**GEOLOGIC HAZARDS EVALUATION AND  
PRELIMINARY GEOTECHNICAL INVESTIGATION  
CROSSROADS NORTH  
MARKSHEFFEL ROAD & STATE HIGHWAY 24  
EL PASO COUNTY, COLORADO**

CTL|T Project No. CS18526.001-105

October 6, 2020

# Soil Geo V\_1 redlines.pdf Markup Summary 12-18-2020

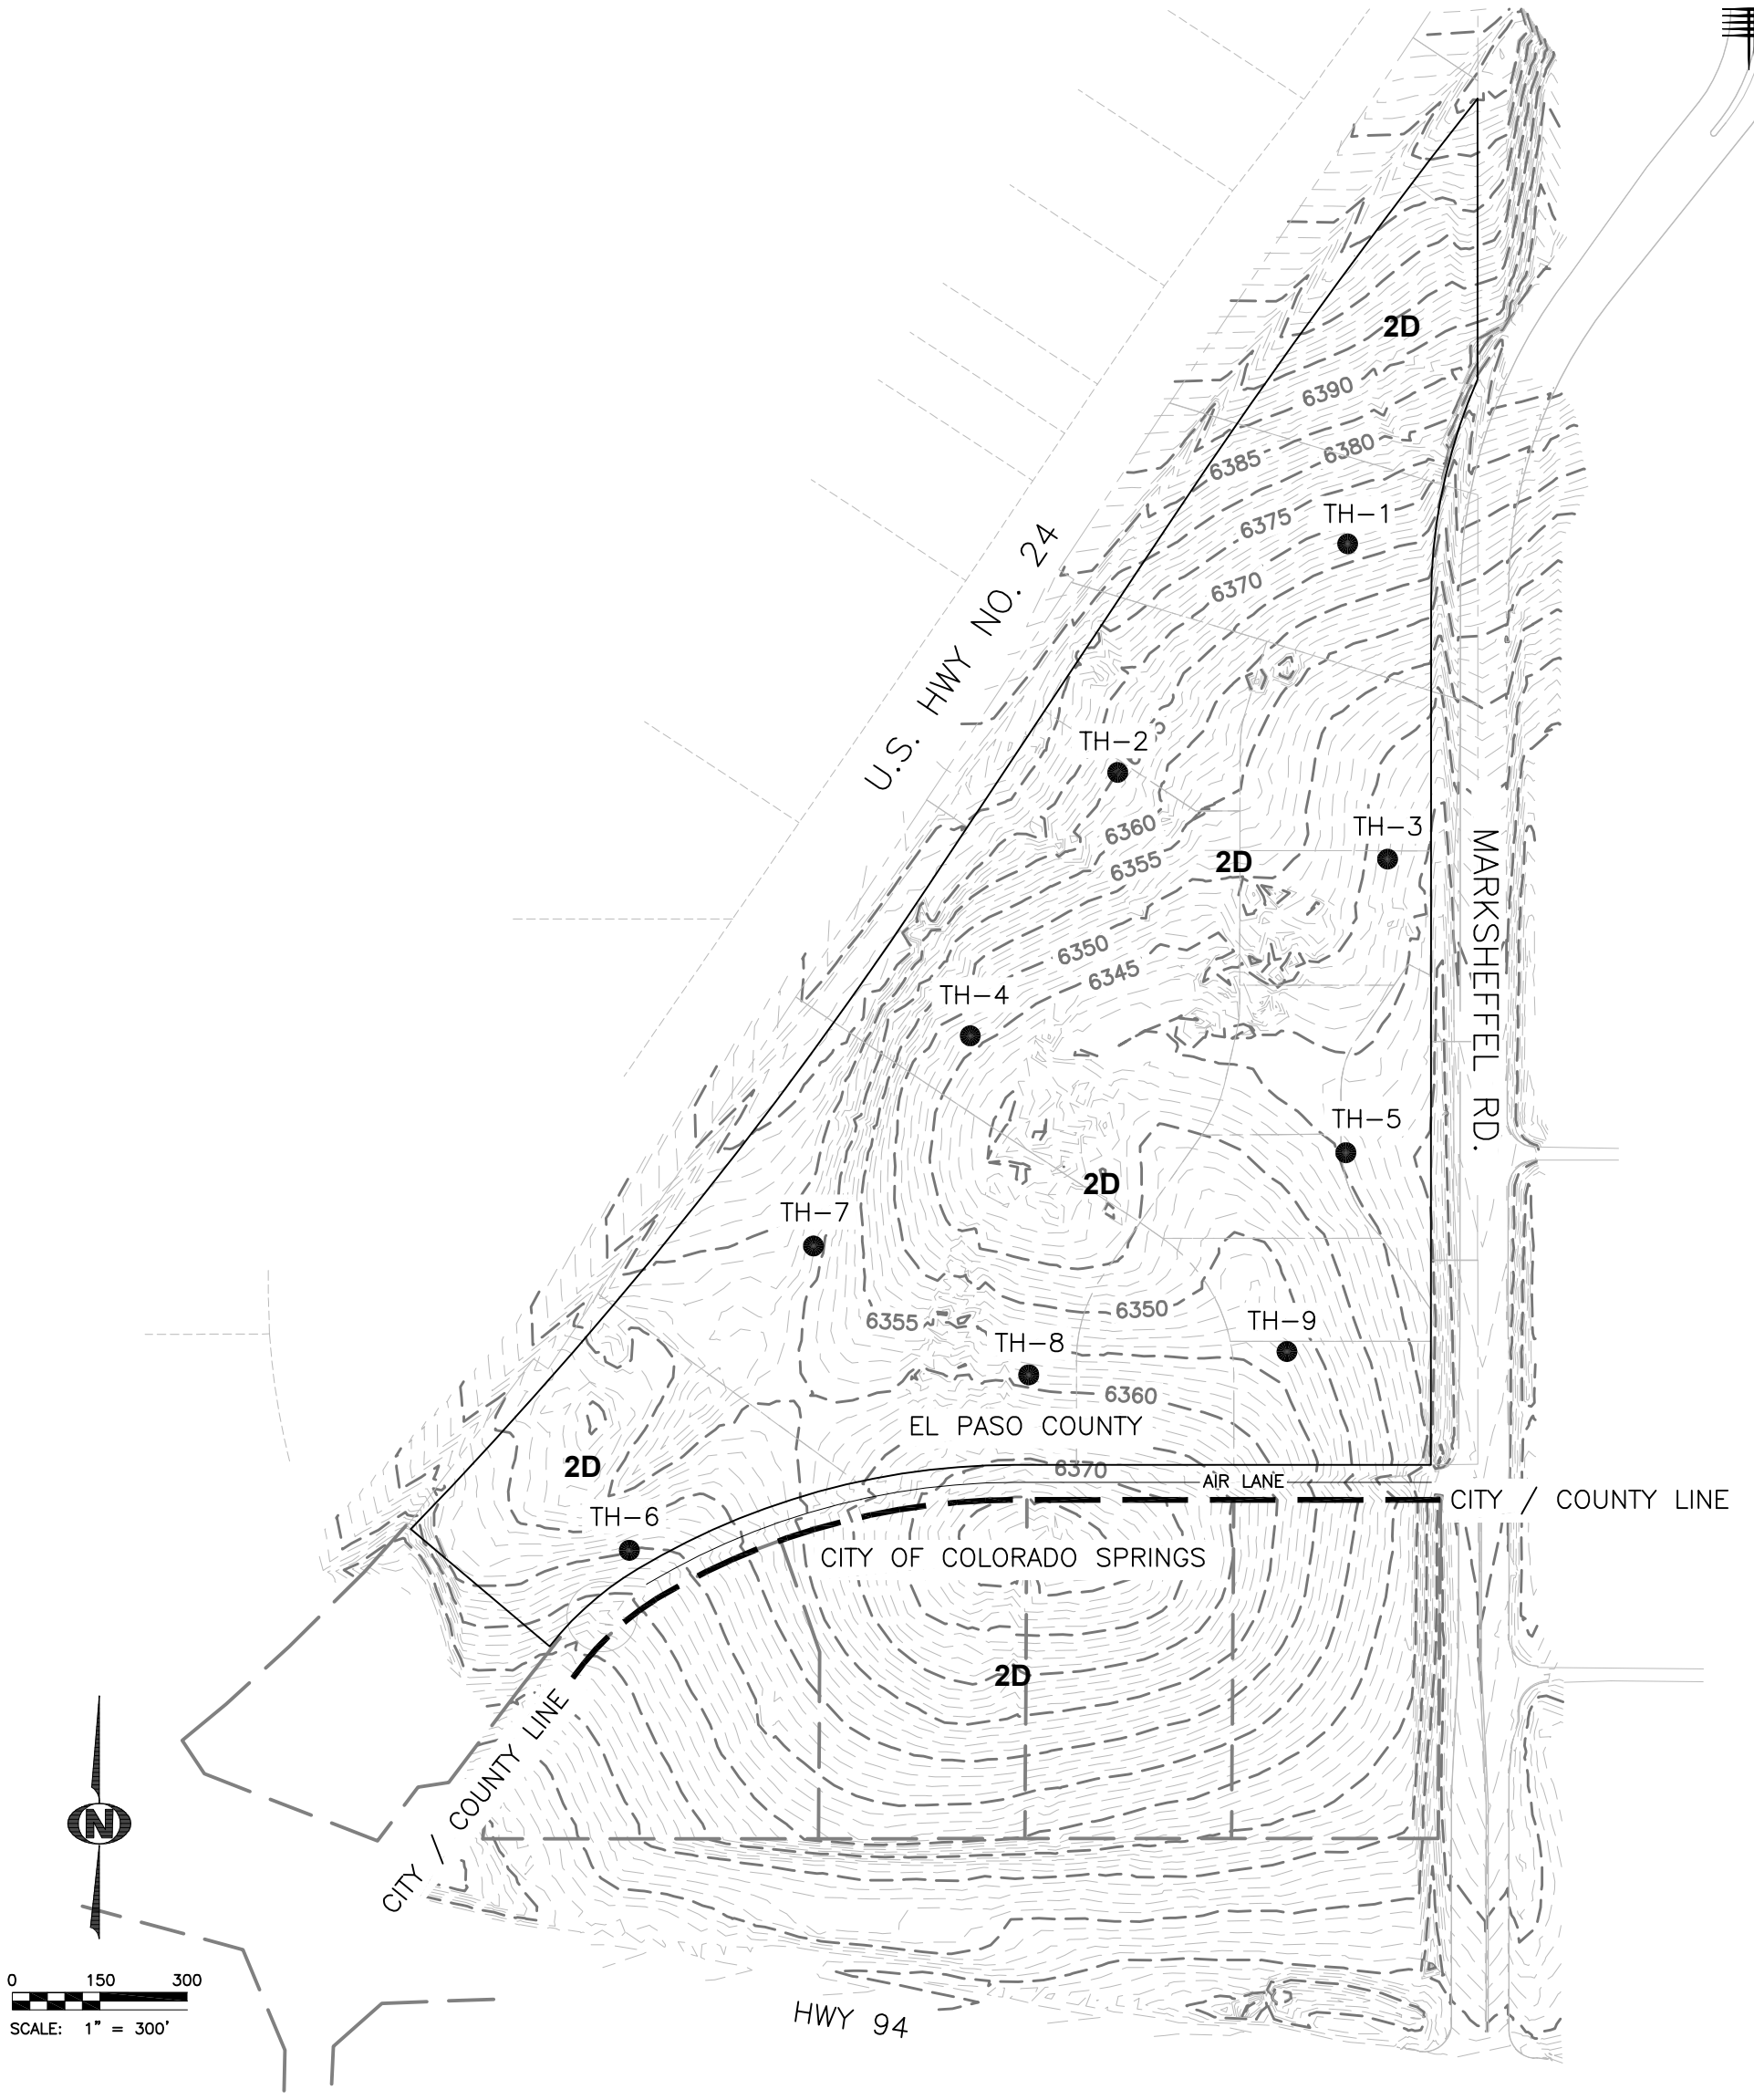
where is the PSW groundwater? at please map

where is the PSW groundwater? at please map
